- (A) Servicing Instruction/Hunter/66  
Flying Controls, Aileron and Elevator Booster Units:  
Revised Adjustment.
- (B) Hunter Mk.4 aircraft and Mks. 7 and 8 pre mod H.811 and H.812.

ING CONTROLS — AILERON AND ELEVATOR  
 TER UNITS — REVISED ADJUSTMENT.

S. I. / HUNTER. / 66

FIG.	HYDRO-BOOSTER	APPLICABILITY
A	PORT AILERON	PRE & POST MOD. H452
	ST'B'D. AILERON	
	ELEVATOR	
B	ELEVATOR	POST MOD. H452
	ST'B'D AILERON	
C	PORT & ST'B'D. AILERON	POST MOD. H684

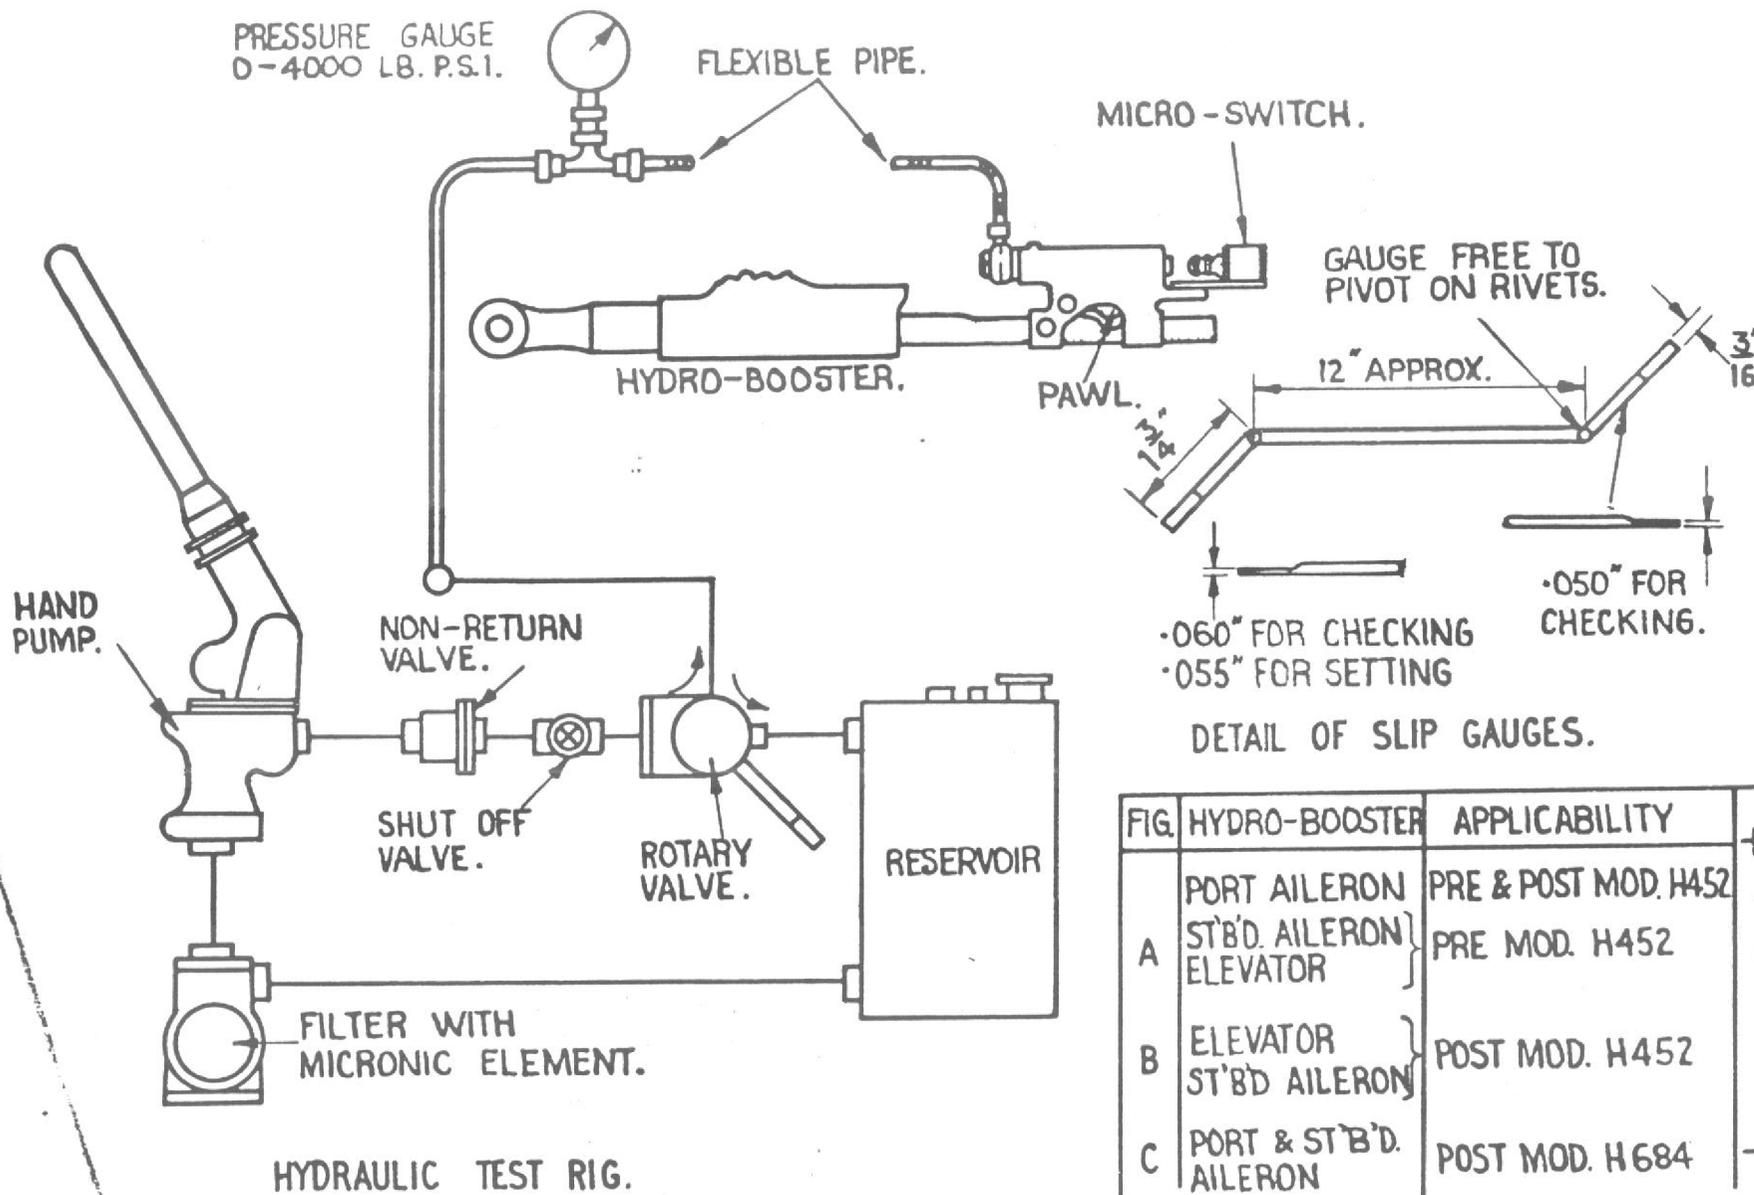
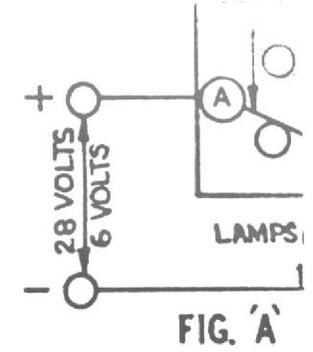
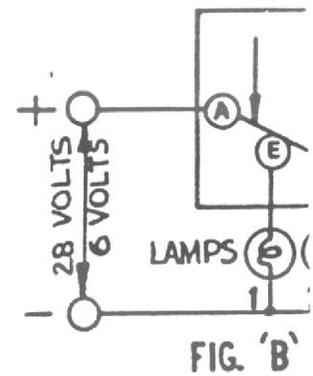
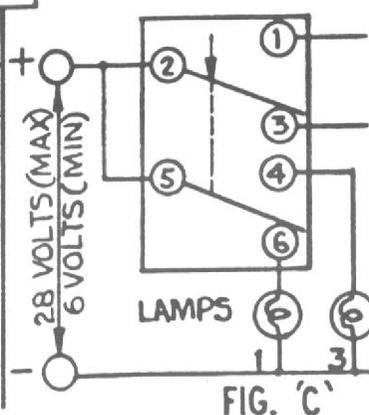
- (C) It has been found from service experience that the setting of the micro-switch mounted on the hydro-booster release units can be revised to obtain a more satisfactory operation of the release unit.

- (b) Disconnect and blank off hydraulic pipe to the banjo attachment on the release unit.
  - (c) Connect release unit to rig, as shown in attached sketch and check for correct operation of micro-switch in accordance with the test instructions given below:-

- (2) Apply a steadily-increasing pressure and check that by the time 650 lb sq./inch is reached, the pawl is fully engaged, i.e. the ram cannot move in the release unit.
- (3) Increase pressure to 2800 lb/sq. inch and after a few seconds reduce to 650 lb./sq. inch. At this pressure check that the pawl is fully engaged and is in contact with bottom of slot.
- (4) Release pressure and insert the 0.055 inch slip gauge between the pawl and the bottom of the ram slot. Apply a pressure of 550 to 650 lb./sq. inch so that the slip-gauge is clamped by the pawl. Position micro-switch tappet to indicate engagement, i.e. lamp 1 should be alight; lamp 3 should be out. Re-adjust tappet until disengagement is indicated, i.e. lamp 3 should be alight; lamp 1 should be out. Lock adjustment.

- (5) Release pressure and replace the 0.055 inch slip gauge by the 0.060 inch gauge. Apply 550 to 650 lb./sq. inch so that the slip gauge is clamped, and check that the switch does not operate, i.e. lamp 1 remains cut and lamp 3 alight.
- (6) Release pressure and replace the 0.060 inch slip gauge by the 0.050 inch gauge. Apply 550 to 650 lb. sq. inch so that slip gauge is clamped, and check that switch operates, i.e. lamp 1 is alight and lamp 3 remains out.
- (7) Release pressure slowly and check that at 150 lb./sq. inch the pawl is clear of the ram slot (disregard the "lead-in" to the slot).
- (8) Switch off and disconnect hydro-booster.
- (9) Re-lubricate the ram and pawl slot with grease XG.275.

- (12) Increase pressure to 2800 lb./sq. inch and, after a few seconds, reduce to 650 lb./sq. inch. At this pressure check that the pawl is fully engaged and that the gap between it and the bottom of the ram slot is within the limit of 0.012 inch.

- (13) Release pressure and insert the 0.055 inch slip gauge between the pawl and the bottom of the ram slot. Apply a pressure of 550 to 650 lb./sq. inch so that the slip-gauge is clamped by the pawl. Move in the micro-switch by turning the knurled knob until lamps 1 and 2 just light. Move out the micro-switch until disengagement is indicated, i.e. lamps 3 and 4 should be alight and lamps 1 and 2 out. (If more than  $\frac{1}{4}$  turn of the knob is needed on moving out, the switch should be inspected for excessive differential). Lock micro-switch.

- (14) Release pressure and replace the 0.055 inch slip gauge by the 0.060 inch gauge. Apply 550 to 650 lb./sq. inch so that the slip gauge is clamped. Depress the micro-switch plunger by hand until lamps 1 and 2 are alight. Release plunger slowly and check that lamps 3 and 4 are alight and lamps 1 and 2 are out when the plunger is resting on the end of the release unit piston rod. Ensure by moving the plunger sideways that it is fully out.

- (15) Release pressure and replace the 0.060 inch slip gauge by the 0.050 inch gauge. Apply 550 to 650 lb. sq. inch so that the slip gauge is clamped. Depress the micro-switch plunger by hand until lamps 1 and 2 are alight. Release plunger and check that lamps 1 and 2 remain alight and lamps 3 and 4 are out.

- (16) Release pressure slowly and check that at 150 lb./sq. inch the pawl is clear of the ram slot (disregard the "lead-in" to the slot).
- (17) Apply pressure slowly and check that by the time 500 lb./sq. is reached the micro-switch indicates engagement, i.e. lamps 1 and 2 are alight.
- (18) Release pressure and disconnect rig and electrics.
- (19) Re-lubricate the ram and pawl slot with grease XG.275.
- (d) Reconnect all pipes. Bleed and test hydraulic system with power rig in accordance with A.P.4347, Vol.1 series, Section 5, C.
- (e) Restore aircraft to normal.
